Addendum No. 1

PROJECT: WOODROW WILSON HOUSE BUILDING SYSTEMS UPGRADES

RE: ADDENDUM NO. 1 TO REQUEST FOR PROPOSALS, ISSUED MARCH 2, 2022

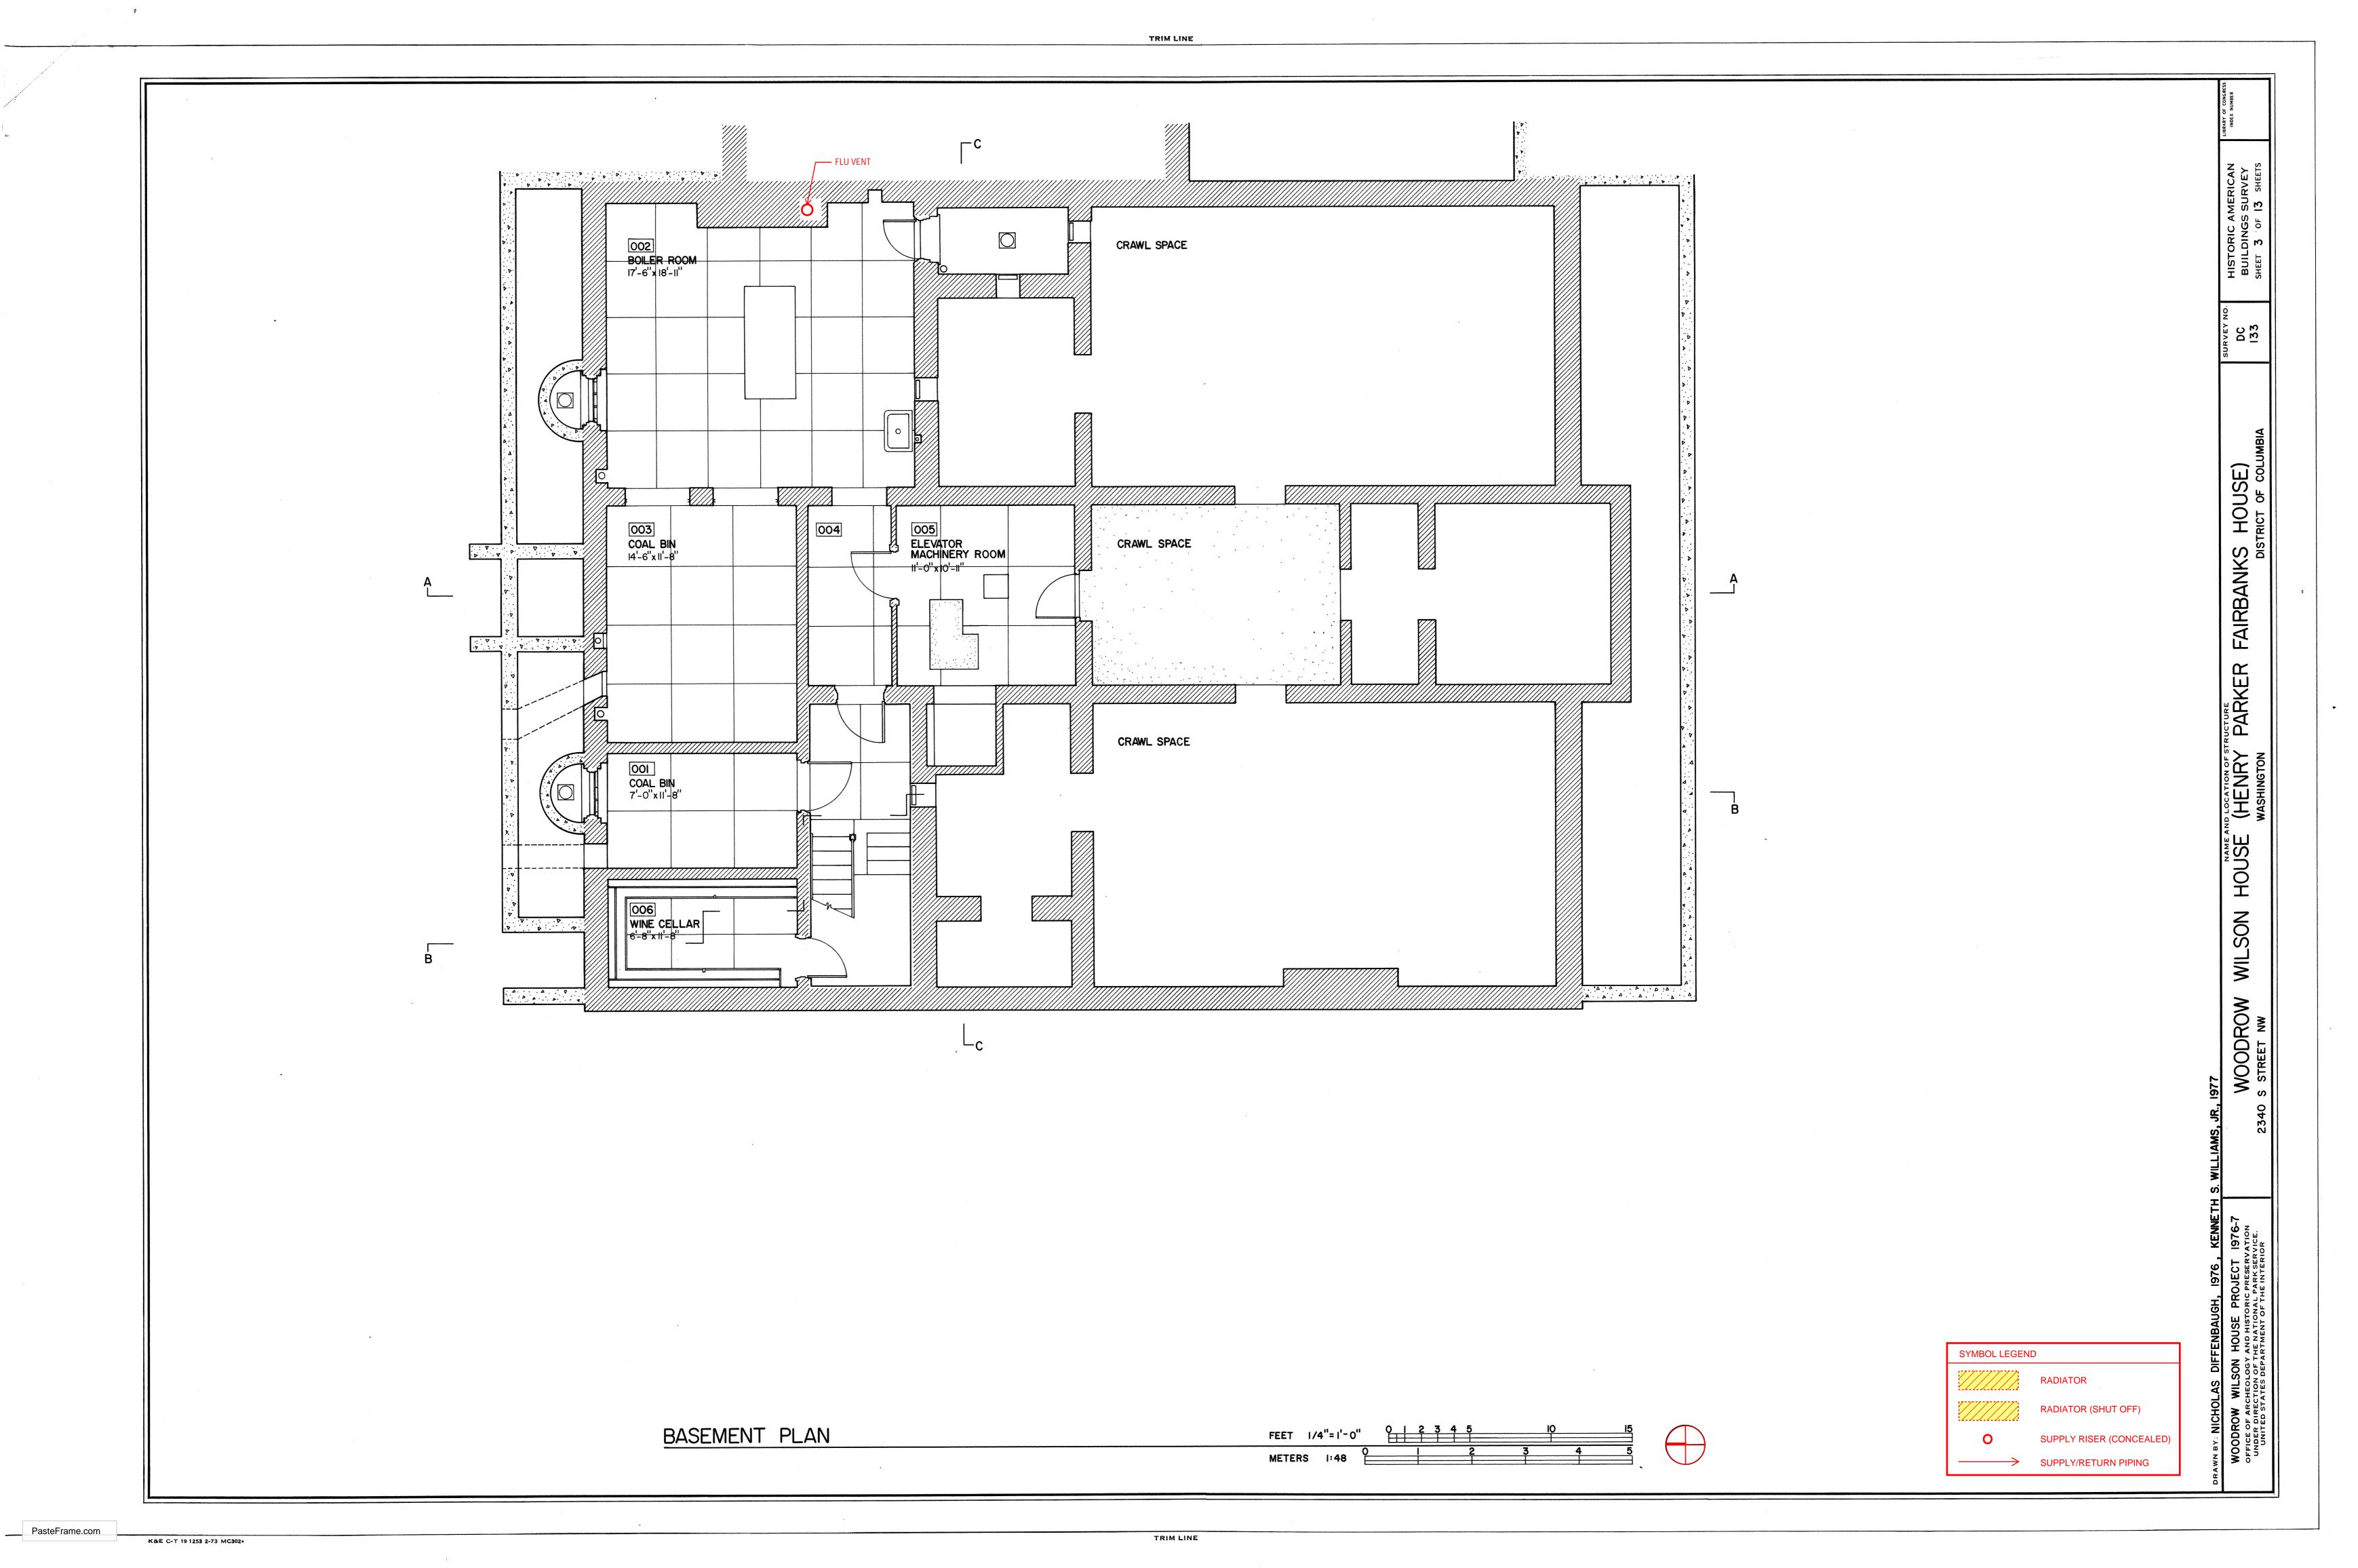
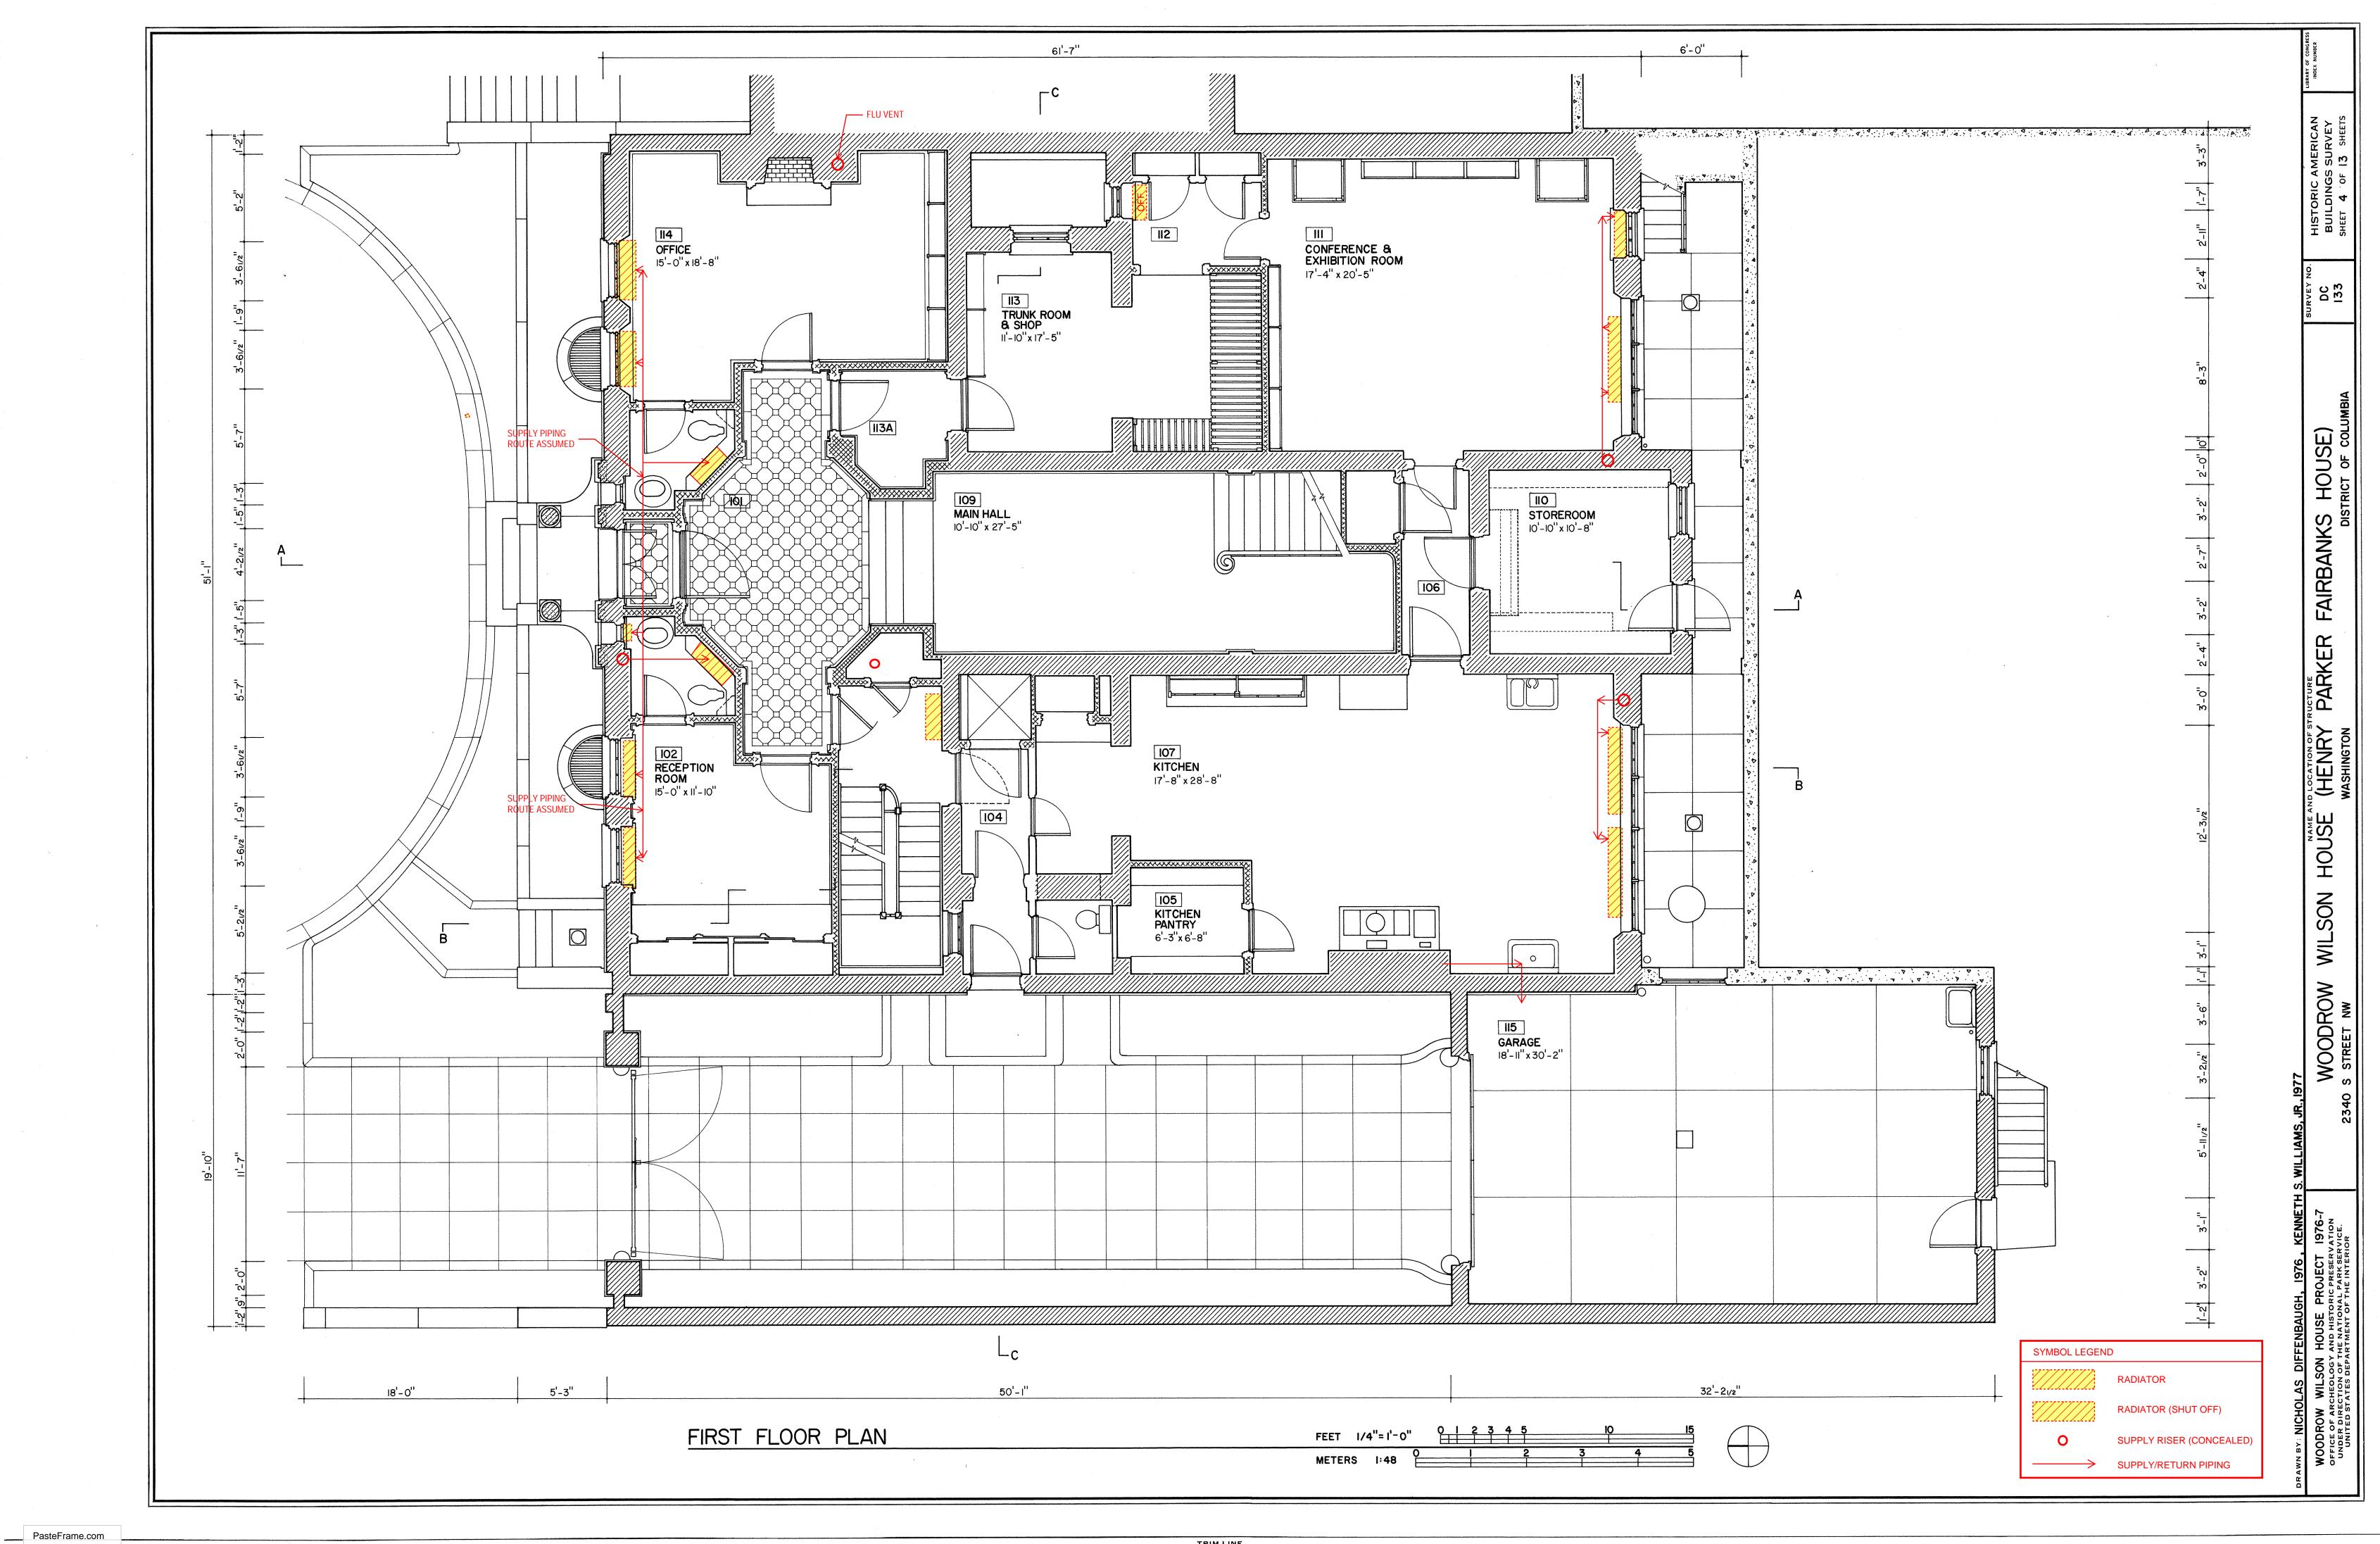
- Q: Would the National Trust provide the marked-up plan of the existing steam piping routing that was discussed during the walkthrough?
- A: The steam piping routing plan is attached to this Addendum. Note, these riser diagrams were determined by thermal imaging and may be incomplete.

- A: The steam piping routing plan is attached to this Addendum. Note, these riser diagrams were determined by thermal imaging and may be incomplete.
- Q: Please confirm that budget pricing to be provided is for the MEP costs only. Cost for Architectural work is by others.
